# PREVOST

## Warranty Bulletin

96-25A

Date: **November 1997**  
 Section: **22**  
 Subject: **RE-ENFORCEMENT OF A/C RECEIVER TANK SUPPORT BRACKET**  
 Revision A:

FIGURE 6: SUPPORT BRACKETS

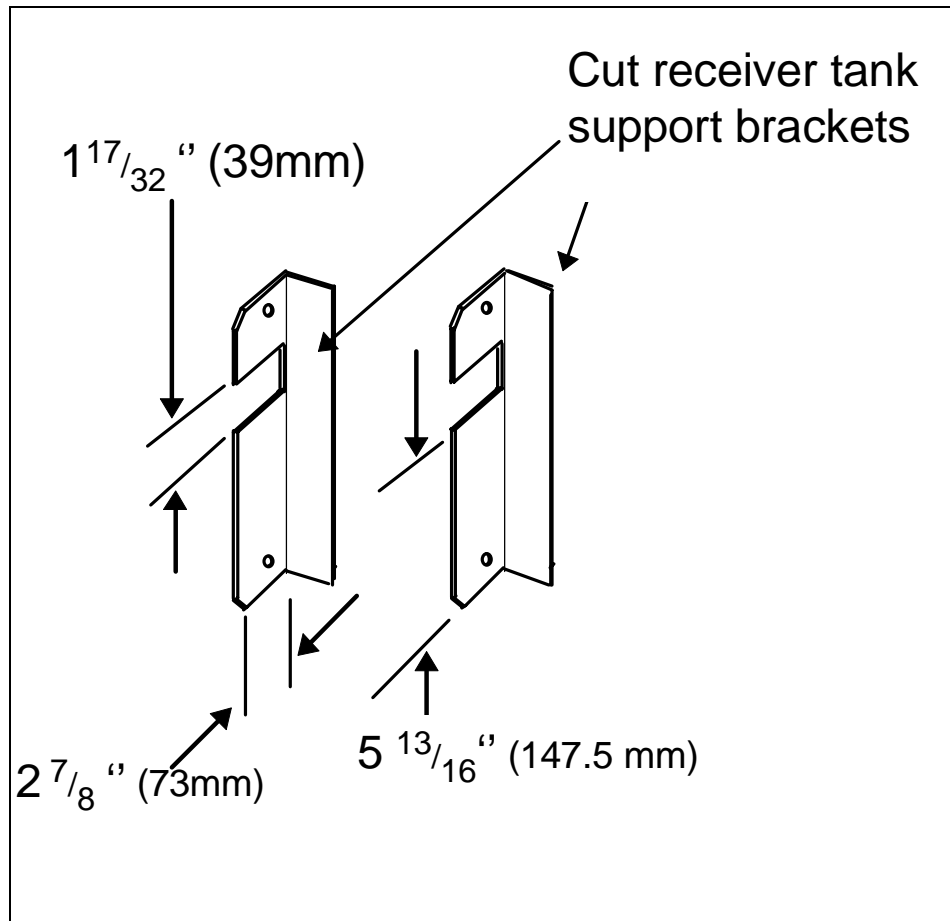
1. Cut the support brackets as shown in Figure 6.

FIGURE 7: A/C COMPARTMENT RE-ENFORCEMENT ASSEMBLY

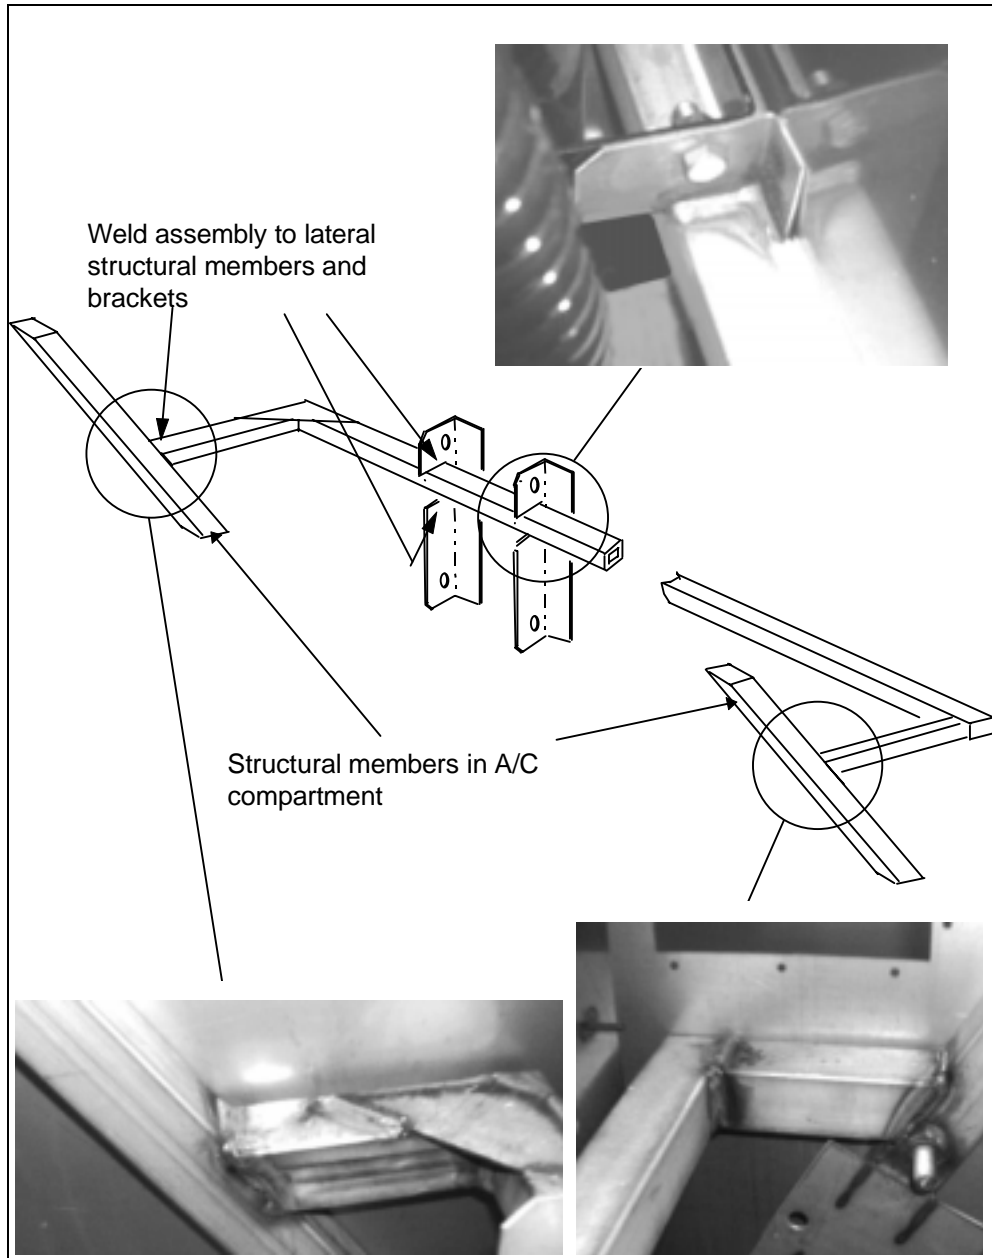
2. Position and weld the re-enforcement assembly as shown in Figure 5 and 7.

FIGURE 8: SUPPORT BRACKETS

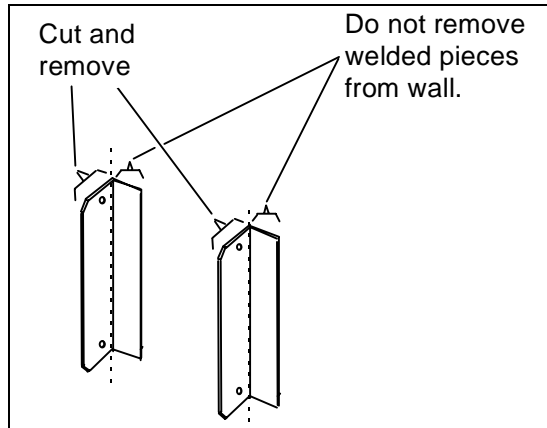
1. Cut brackets where shown in Figure 8. This is required to permit installation of new re-enforcement assembly. To prevent damages to the wall it is recommended to leave the welded halves on the wall.

FIGURE 9: A/C COMPARTMENT RE-ENFORCEMENT ASSEMBLY

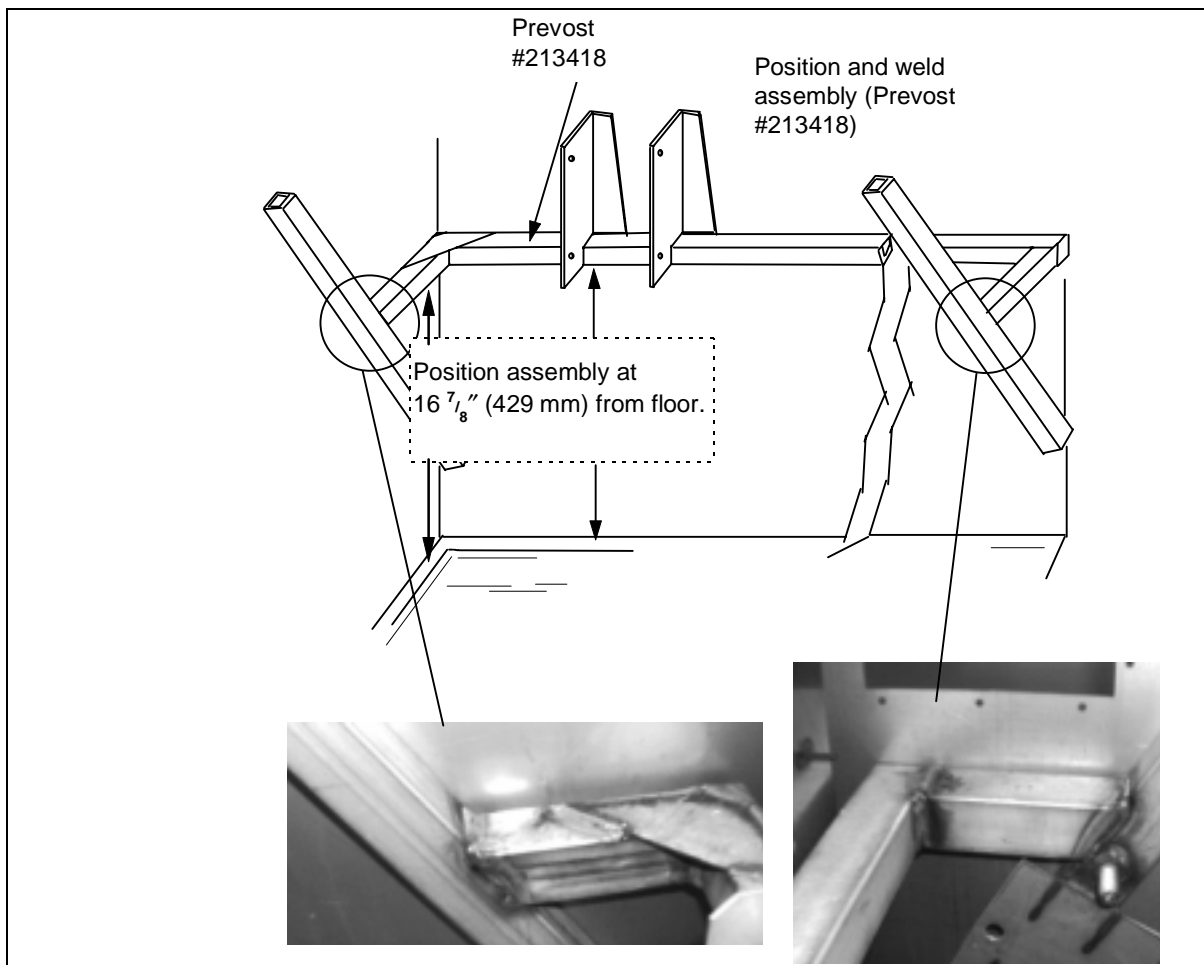
2. Position and weld new support assembly as shown in Figure 9.
